Work Order ID 81843

Item Name: Replacement Skidtube

DRAWING NO. D2580	TITLE 205 SKIDTUBE ASSEMBLY	REV. E	DART AEROSPACE LTD ENGINEERING ORDER	D.E.O. NO. D2580-E-1	SHEET NO. SHEET 1 OF 1	SCALE NTS
DRAWN <i>UP</i>	CHECKED <i>ASS</i>	MFG. APPR. <i>ER</i>	APPROVED <i>[Signature]</i>	DE APPR. <i>[Signature]</i>		
DATE 11.12.13	DATE 11.12.13	DATE 11.12.13	DATE 11.12.13	DATE 11.12.13

CHANGE ALL C'BORED WELDED CROSSBOLT SPACERS TO SWAGED SPACERS

SECTION B-B, F-F, I-I
NOT TO SCALE

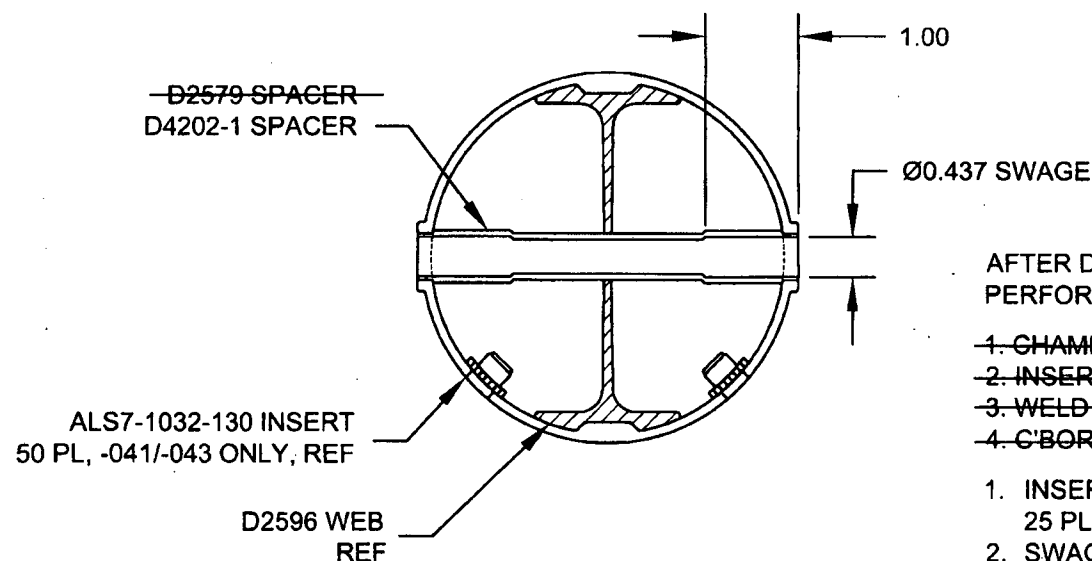
SECTION B-B, SECTION F-F, & SECTION I-I ARE AMENDED AS FOLLOWS
FOR ALL HOLES THAT WERE ORIGINALLY C'BORED:

*** FOR -045 SKIDTUBE ONLY:**

WELD 4X D2579 SPACERS PER DWG
IN LOCATIONS MARKED "NO C'BORE".
REF SHEET 4 OF DWG.

AFTER DRILLING AND BENDING ASSEMBLY
PERFORM THE FOLLOWING FOR Ø0.508 HOLES ONLY:

1. CHAMFER HOLE 0.050 X 45°
2. INSERT D2579 SPACER (20 PLACES)
3. WELD INTO PLACE AND GRIND FLUSH
4. C'BORE D2579 SPACER TO Ø0.437 X 1.00 DEEP

1. INSERT D4202-1 SPACER, 20 PL (-041) OR 20 PL (-045) OR 25 PL (-047)
2. SWAGE TO Ø0.437 X 1.00 DEEP PER QSI 002
3. TRIM / GRIND FLUSH PER QSI 002
